# **Firmware Change Note**

- 3Dv2 eMMC5.1 Products -

QRA Division Dec. 22, 2016

CV bygiv Inc	Firmerray Change Notification	PCN No.	F1612-004-N-00	
SK hynix Inc.	Firmware Change Notification	Date	2016-12-22	
PCN Title	FCN for 3Dv2 eMMC5.1			
Purpose	Change CMDQ handling policy PRV value: 0xA2	Description of Change	Change Command Queue handling policy (Aligned with Qualcomm policy)	
Customer	All Customers			
Device	3Dv2 eMCP5.1			
Part No.	221Ball eMCP5.1 Product : H9TQ52ADFTMCUR (64+24) / H9TQ52ACLTMCUR (64+32)		Date Issued : 2016-12-22  Prepared by : Y.E. Cho E-mail : youngeui.cho@sk.com  Checked by : K.L. Lee EMMC Quality Engneering Project  Approved by : VP H.G. Lee Solution Quality Group	
Remark	3Dv2 eMMC5.1 - Qualcomm CMDQ PRV 0xA2			
Response Due Date	- <b>Effective Date</b> Jan. 2017 Shipping (WW701 on Packing Label)		Solution Quality Group

### Firmware Change Note

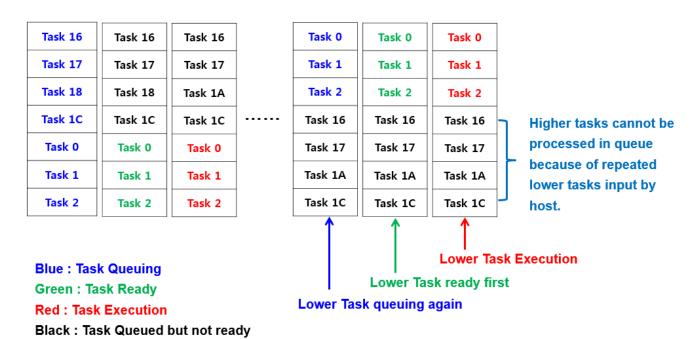
- Change Command Queue handling policy

### ✓ Root Cause

: Timeout occurs because command queue handling is not aligned with Qualcomm policy.

eMMC processes lower number tasks while higher number tasks are waiting in queue

and host sends lower number tasks repeatedly, so higher number tasks cannot be processed within host timeout.

### ✓ Solution

: Device will process all task ID sequentially.

Firmware scans tasks in queue and executes all task equally.
